MEMORANDUM

File No.: DRV22-00569

Subject: **POLARIS AT TOTEM LAKE PROJECT
DESIGN RESPONSE CONFERENCE**

12335 120TH AVENUE NE, KIRKLAND, WASHINGTON 98034
DESIGN RESPONSE CONFERENCE - ROUND 1
07.25.2022

A // SCALE

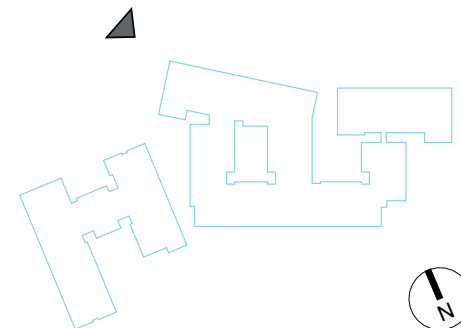
The DRB debated the three massing options presented by the applicant and concluded the project should move forward to a Design Response Conference with Option #3. Throughout the two CDC meetings, the DRB discussed the mass and scale of the building with regard to modulation (vertical & horizontal) of the building form proposed. The DRB directed the applicant to incorporate more modulation in the building façade of Tower A along 120th Avenue NE as the design progresses and look at ways to reduce the mass of Tower B adjacent to Evergreen Academy.

- (A) Five-story mass over the base provides roughly a 2/3 proportion along the 120th Ave. NE frontage. This element continues around the East facade of the building.
- (B) Upper Building Proportion Cantilevered over Base structure by 8'-0".
- (C) Horizontal building articulation using materiality to help define the facade transparency and promote a residential feel.
- (D) Building articulation using material transitions (in-plane) to break down the facade.

COMMON OPEN SPACE

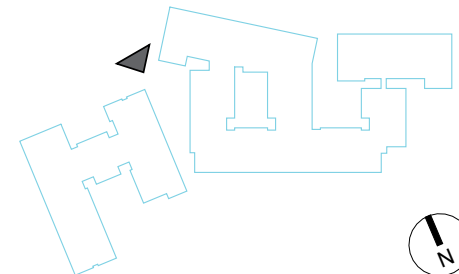
The DRB discussed the open spaces proposed on by the project, particularly the public pedestrian plaza located in front of the commercial space along 120th Avenue NE. The Board encouraged the applicant to study that space and expressed concern about its usability given the northerly orientation.

- (A) Incorporate common open space into multi-family residential uses. In the Totem Lake Business District, where very high-density residential uses are allowed, the quality of the space in providing respite from the buildings on the site is more critical than the amount of space provided. In some developments, multiple smaller spaces may be more useful than one, larger space. Special recommendations for common open space:

- (B) Consider open space as a focal point of the residential development.
- (C) Where possible, open space should be large enough to provide functional leisure or recreational activity. For example, long narrow spaces rarely, if ever, can function as usable common space.

- (D) Open space should provide for a range of activities and age groups. Children's play areas in particular should be visible from dwelling units and positioned near pedestrian activity.

COMMON OPEN SPACE

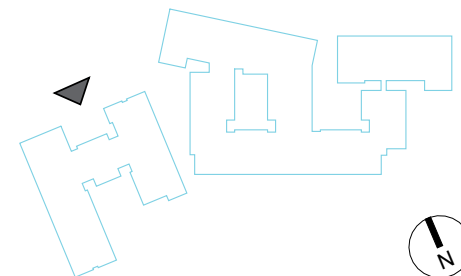
The DRB discussed the open spaces proposed on by the project, particularly the public pedestrian plaza located in front of the commercial space along 120th Avenue NE. The Board encouraged the applicant to study that space and expressed concern about its usability given the northerly orientation.

- (A) Incorporate common open space into multi-family residential uses. In the Totem Lake Business District, where very high-density residential uses are allowed, the quality of the space in providing respite from the buildings on the site is more critical than the amount of space provided. In some developments, multiple smaller spaces may be more useful than one, larger space. Special recommendations for common open space:

- (B) Consider open space as a focal point of the residential development.
- (C) Where possible, open space should be large enough to provide functional leisure or recreational activity. For example, long narrow spaces rarely, if ever, can function as usable common space.

- (D) Open space should provide for a range of activities and age groups. Children's play areas in particular should be visible from dwelling units and positioned near pedestrian activity.

COMMON OPEN SPACE

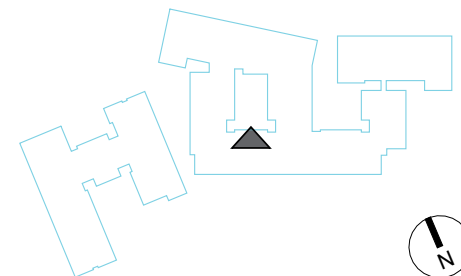
The DRB discussed the open spaces proposed on by the project, particularly the public pedestrian plaza located in front of the commercial space along 120th Avenue NE. The Board encouraged the applicant to study that space and expressed concern about its usability given the northerly orientation.

- (A) Incorporate common open space into multi-family residential uses. In the Totem Lake Business District, where very high-density residential uses are allowed, the quality of the space in providing respite from the buildings on the site is more critical than the amount of space provided. In some developments, multiple smaller spaces may be more useful than one, larger space. Special recommendations for common open space:

- (B) Consider open space as a focal point of the residential development.
- C. Where possible, open space should be large enough to provide functional leisure or recreational activity. For example, long narrow spaces rarely, if ever, can function as usable common space.

- (D) Open space should provide for a range of activities and age groups. Children's play areas in particular should be visible from dwelling units and positioned near pedestrian activity.

COMMON OPEN SPACE

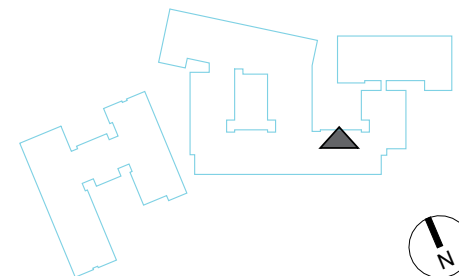
The DRB discussed the open spaces proposed on by the project, particularly the public pedestrian plaza located in front of the commercial space along 120th Avenue NE. The Board encouraged the applicant to study that space and expressed concern about its usability given the northerly orientation.

- (A) Incorporate common open space into multi-family residential uses. In the Totem Lake Business District, where very high-density residential uses are allowed, the quality of the space in providing respite from the buildings on the site is more critical than the amount of space provided. In some developments, multiple smaller spaces may be more useful than one, larger space. Special recommendations for common open space:

- (B) Consider open space as a focal point of the residential development.
- (C) Where possible, open space should be large enough to provide functional leisure or recreational activity. For example, long narrow spaces rarely, if ever, can function as usable common space.

- (D) Open space should provide for a range of activities and age groups. Children's play areas in particular should be visible from dwelling units and positioned near pedestrian activity.
